**Re: Office/Warehouse, 5454 Venice Ave NE, Grading and Drainage Plan
Engineer's Stamp dated 2-1-10 (B18/D017)**

**RE: OFFICE WAREHOUSE, 5454 VENICE AVE NE, GRADING AND
DRAINAGE PLAN ENGINEER'S STAMP DATED 1-8-10 (B18/D017)**

GRADING AND DRAINAGE PLAN

CG-101

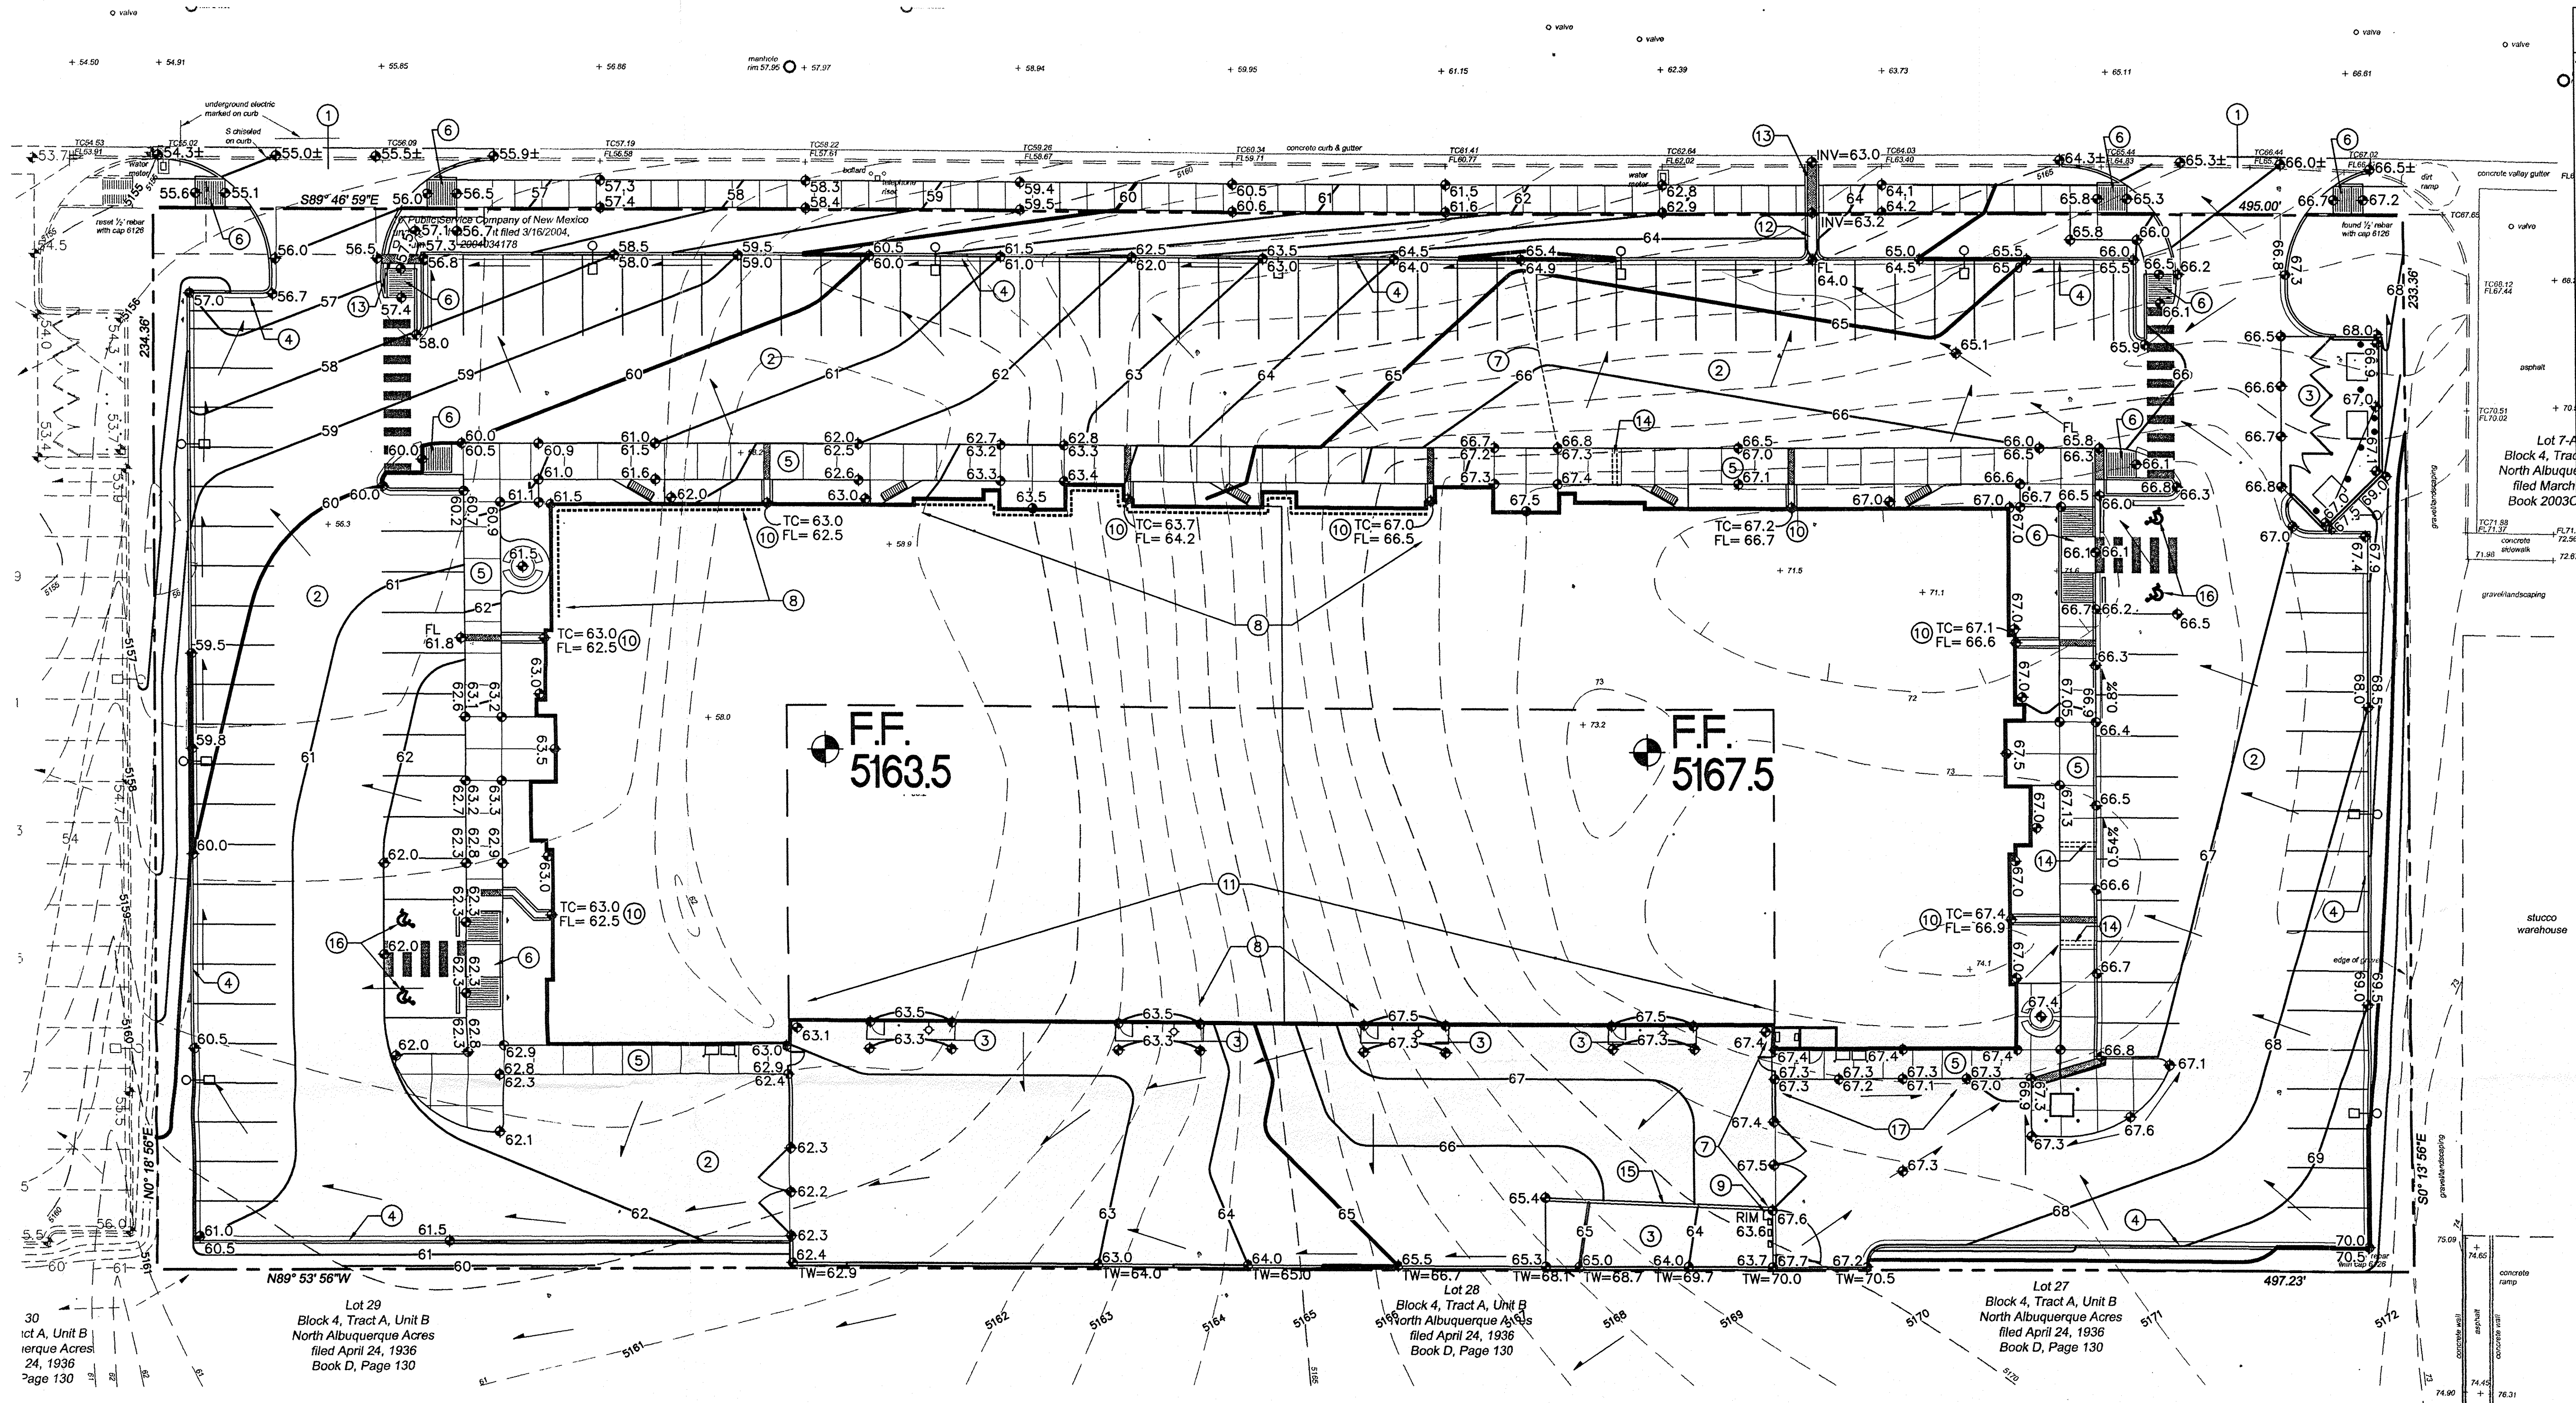
1. The Basin 2 culvert equation was for one two-foot sidewalk culvert with a six-foot curb opening (6' foot total orifice width) per the detail on sheet CG-102. Please see the attached channel calculation which clarifies that the two-foot culvert will provide adequate capacity for the flow requirement after the initial curb opening.
2. Top of wall information added along length of retaining wall.

CG-102

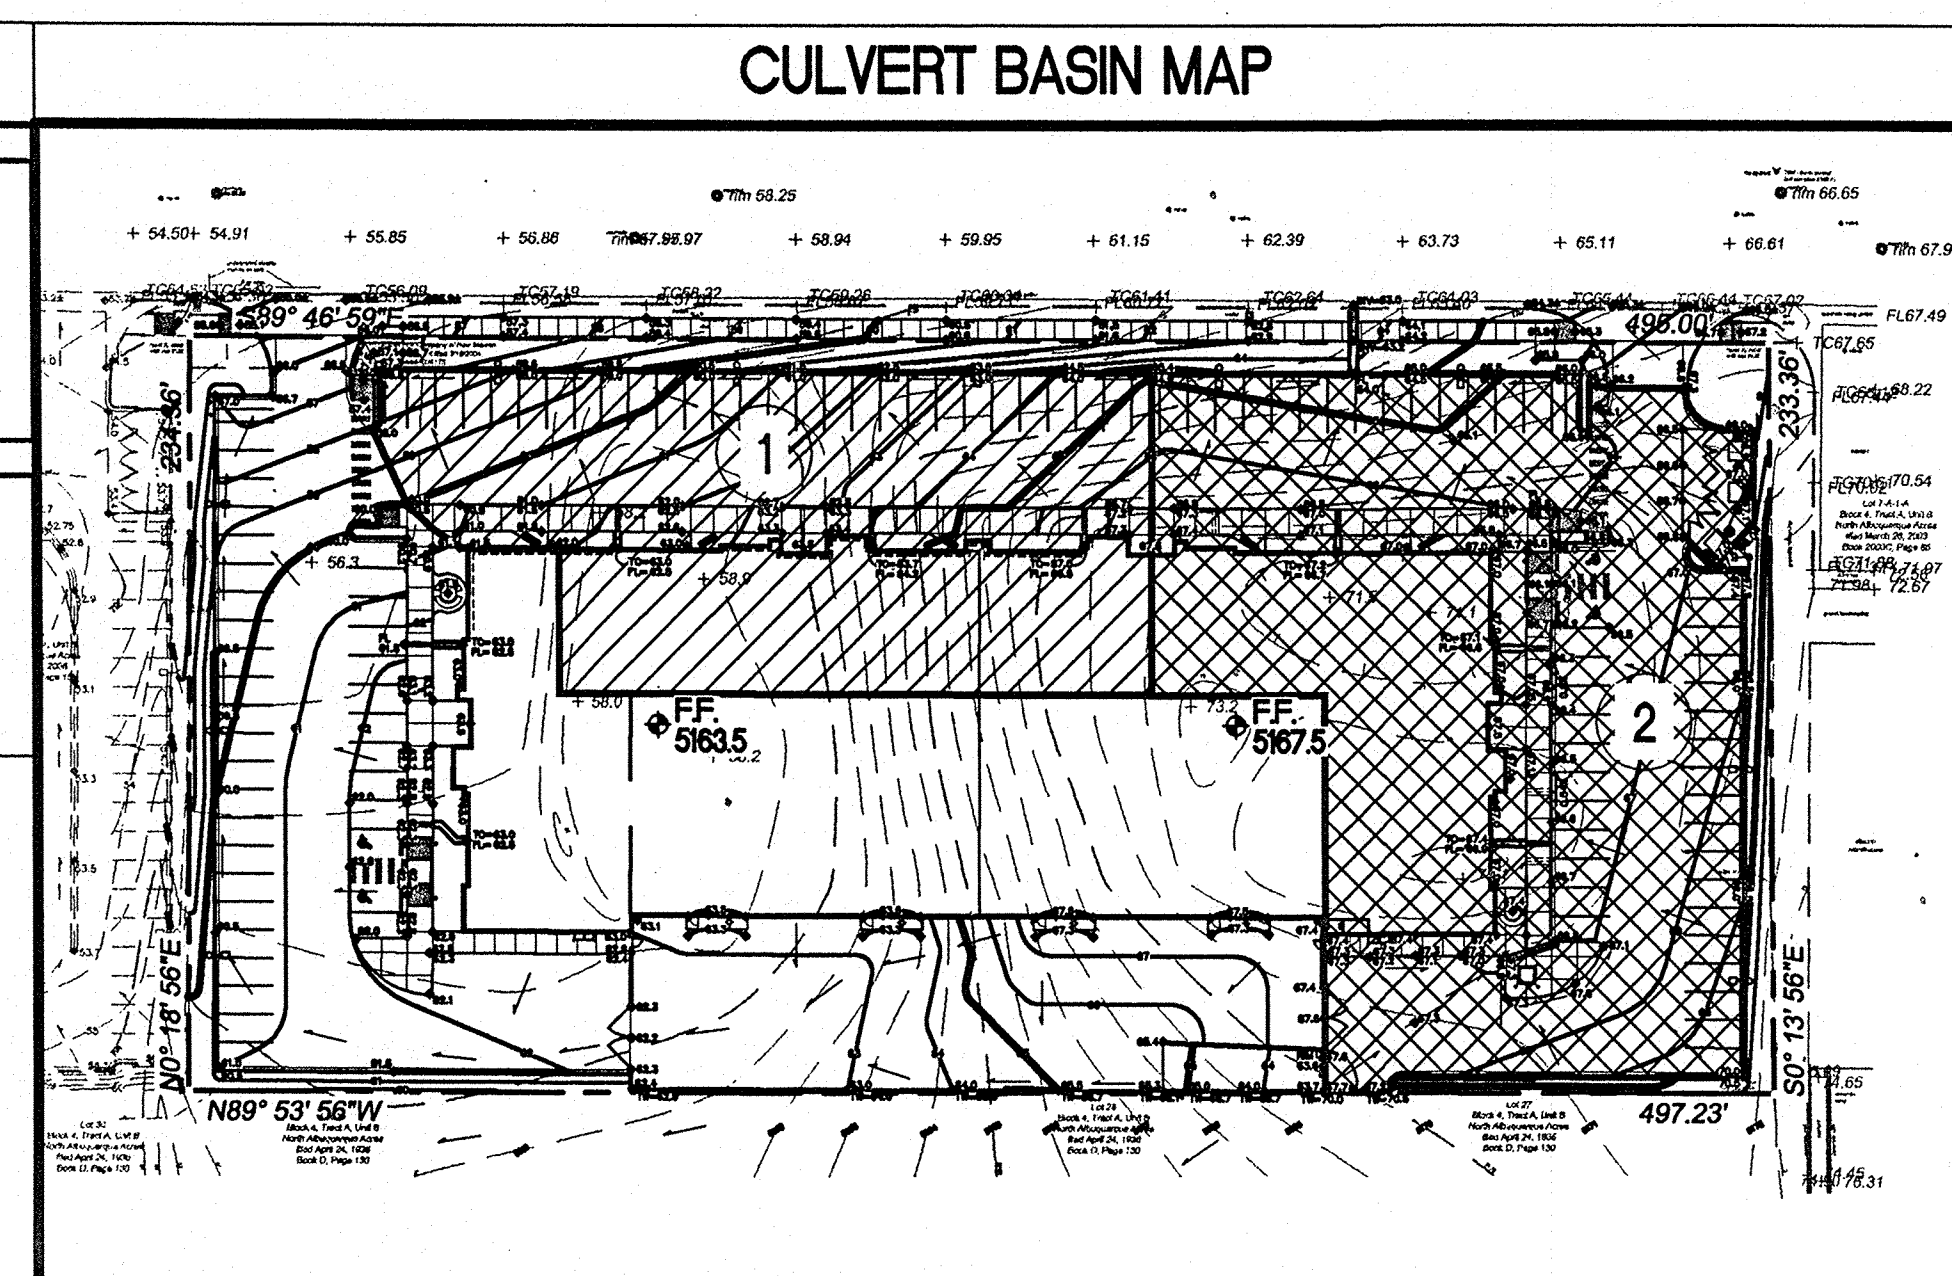
I disagree that the Basin 2 Culvert equation Curb Opening should be modeled as a 6 foot wide weir. It is closer to a 2 foot wide weir with an end treatment on the inlet. After a fairly lengthy search to determine the increase in flow due to the inlet condition, I figure a close approximation was to use a weir length of 4 feet. The resulting capacity was 4.7 cfs, which is greater than 3.7 cfs, therefore it is acceptable.
